M4 Roper Road Westbound On Ramp

Community Consultation Report

April 2021

Figure 1: Map of the proposed ramp

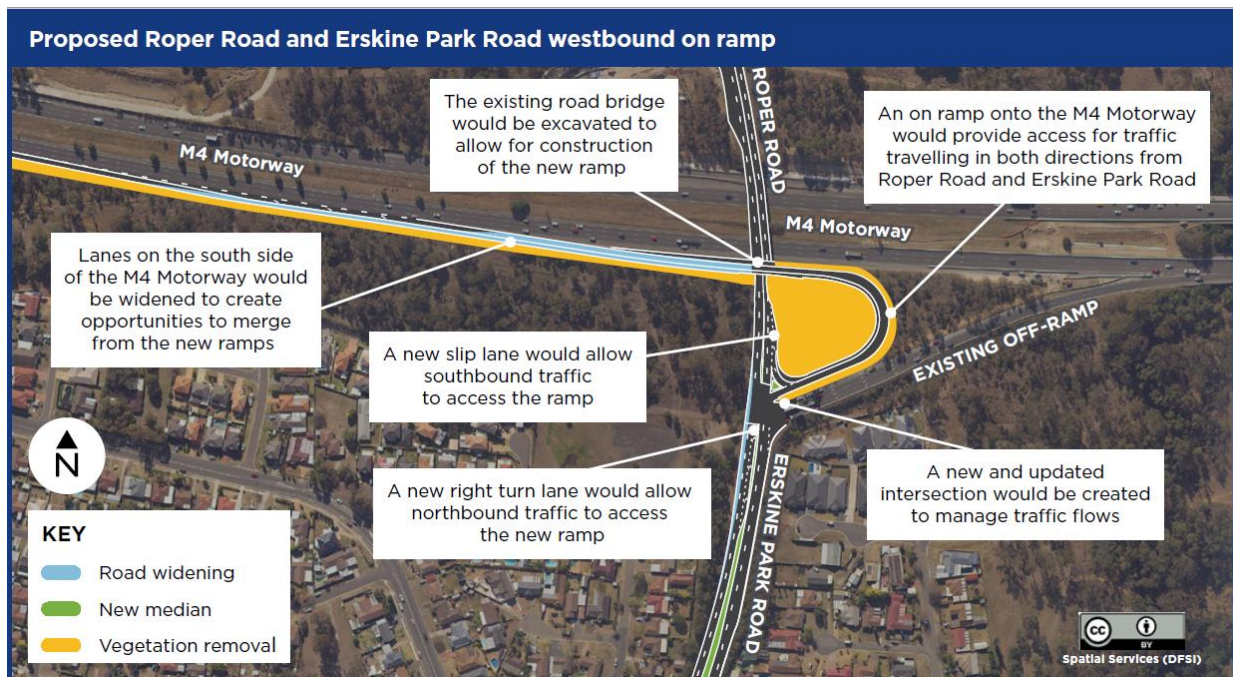
Loop configuration	1	<p>Another "cloverleaf" Westbound On-Ramp is not the best option, because it restricts the free flow of traffic, however, given that this section of the M4 Motorway is in desperate need of an additional Westbound On-Ramp; something is far better than nothing at all. "Cloverleaf" on-ramps restrict the free flow of traffic as drivers are required to make a right turn across traffic to access the On-Ramp. This then requires additional placement of Traffic Lights and will always result in queueing for access to the On-Ramp. "Cloverleaf" on-ramps are counter-productive.</p> <p>Entry onto the ramp needs to be as quick as possible with as little stop-starting as possible to cater for added traffic.</p>	<p>A G-loop configuration for the new ramp was required by a number of design issues specific to this location including:</p> <ul style="list-style-type: none"> • A Threatened Ecological Community to the west of Erskine Park Road; • The G-loop configuration reduces the amount of vegetation clearance • The G-loop design avoids impact to the existing stormwater basin in this location and impact to the drainage infrastructure which manages stormwater in this area.

Loop location	7	<p>A slip road on the left side of Roper Road makes more sense and keeps the traffic flowing north with less congestion. Having the on ramp go directly onto the M4 would mean:</p> <ul style="list-style-type: none"> - No danger of a collision of a tired truck driver having a head on collision with a vehicle exiting the M4 onto Erskine Park Road - No traffic has to cross at lights - Less chaos for traffic travelling South - A cheaper construction option - No excavation of the bridge - Less impact on residential properties <p>There are other examples of loop ramps not working including: Banks Drive exit onto Mamre Road.</p> <p>The existing off ramp is also very close to the proposed new ramp and there is a potential for northbound motorists to make an error and turn into the wrong road.</p>	<p>A G-loop configuration for the new ramp was required by a number of design issues specific to this location including:</p> <ul style="list-style-type: none"> • A Threatened Ecological Community to the west of Erskine Park Road; • The G-loop configuration reduces the amount of vegetation clearance • The G-loop design avoids impact to the existing stormwater basin in this location and impact to the drainage infrastructure which manages stormwater in this area •

Ramp length	1	<p>Consider having the ramp length go to Bennett Road, not the normal 100m that seems to be standard. Longer ramps are commonplace in QLD and allow for smoother traffic integration. At present, M4 eastbound traffic onto Roper Road is forced to merge almost immediately. This is one of the biggest bottlenecks in the morning.</p>	<p>The length of the ramp has been determined based on national road design standards and considering local requirements. The length is designed to safely integrate with the M4 Smart Motorway.</p>
